**RESPONSE TO UNITED STATES ENVIRONMENTAL PROTECTION AGENCY (EPA)
COMMENTS DATED MAY 16, 2007 (E-MAIL FROM PETER RAMANAUSKAS) ON THE
INTERIM MEASURES WORK PLAN (IMWP)
FOR SWMU 13 – MINE FILL B
NAVAL SURFACE WARFARE CENTER
CRANE, INDIANA**

**RESPONSE TO COMMENTS (RTCs) DATED JUNE 12, 2008
FROM UNITED STATES ENVIRONMENTAL PROTECTION AGENCY (EPA)
(E-MAIL FROM PETER RAMANAUSKAS)
ON THE INTERIM MEASURES WORK PLAN (IMWP) EPA RTCs DATED JUNE 9, 2008
FOR SWMU 13 – MINE FILL B
NAVAL SURFACE WARFARE CENTER
CRANE, INDIANA**

**RESPONSE TO COMMENTS (RTCs) DATED APRIL 10, 2008
FROM UNITED STATES ENVIRONMENTAL PROTECTION AGENCY (EPA)
(E-MAIL FROM PETER RAMANAUSKAS)
ON THE INTERIM MEASURES WORK PLAN (IMWP) RTCs DATED DECEMBER 20, 2007
FOR SWMU 13 – MINE FILL B
NAVAL SURFACE WARFARE CENTER
CRANE, INDIANA**

**DRAINAGE CHANNEL VERIFICATION SAMPLING
SWMU 13 - MINE FILL B
INTERIM MEASURES WORK PLAN
NSWC CRANE
CRANE, INDIANA**

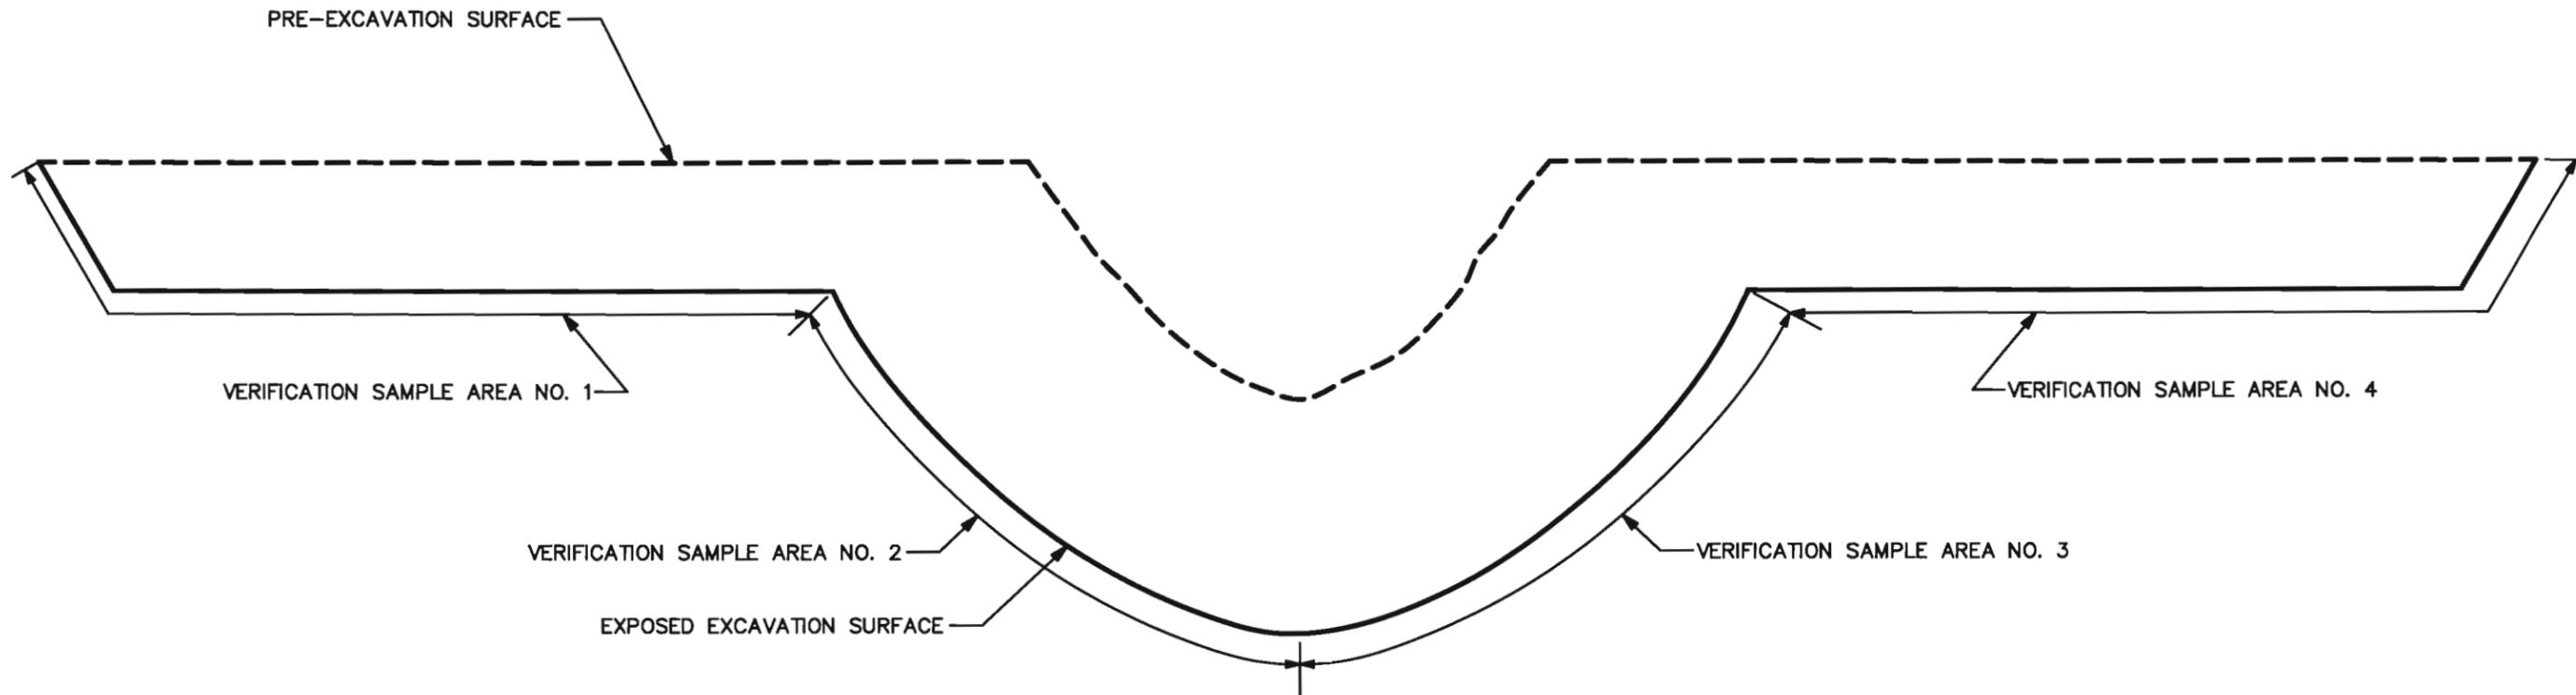
The Navy must take confirmation floor samples. The configuration of the drainage channel or excavation does not eliminate the requirement for confirmation sampling. Please propose a confirmation floor sampling plan.

Response to EPA-6(4-10-08): The excavation shape related to the drainage channel excavation is an irregular shape (see Figure 3-4 in Attachment 2). As a result of the irregular shape, verification samples will be collected from the exposed exaction floor of the channel overflow areas located on each side of the "V / U" shaped channel. Within the "V / U" shaped channel one verification sample will be collected from each of the exposed surface defining the sides of this "V / U" shaped excavation. To illustrate the locations of verification sample collection, a new figure (Figure 5-1 see Attachment 3) has been added to the text and is provide as part of this response to comment document.

- *"Drainage Channel Excavation Areas - Verification samples will be collected from the excavation sidewalls and floors. Due to the irregular shape of the drainage channel excavation (see Figure 3-4), two verification samples will be collected from the exposed overflow floor areas located on each side of the channel (i.e., from the channel overflow areas) and two verification samples will be collected from the exposed surfaces of the drainage channel (Figure 5-1). Verification samples will be composite samples as described in the QAPP (TiNUS, 2006). These four composite samples make up one set of verification samples. At a minimum, one set of verification samples will be collected from each drainage channel segment and for every 100 linear feet of drainage channel excavation. In the event that a drainage pipe is encountered during the drainage channel excavation process, the frequency of verification sample collection will be increased to one set of verification samples for every 25 linear feet of drainage channel excavation. Therefore, based on the proposed length of drainage channel excavation within 100 feet downstream of the piping outlet areas, if drainage pipes are not encountered, seven sets*
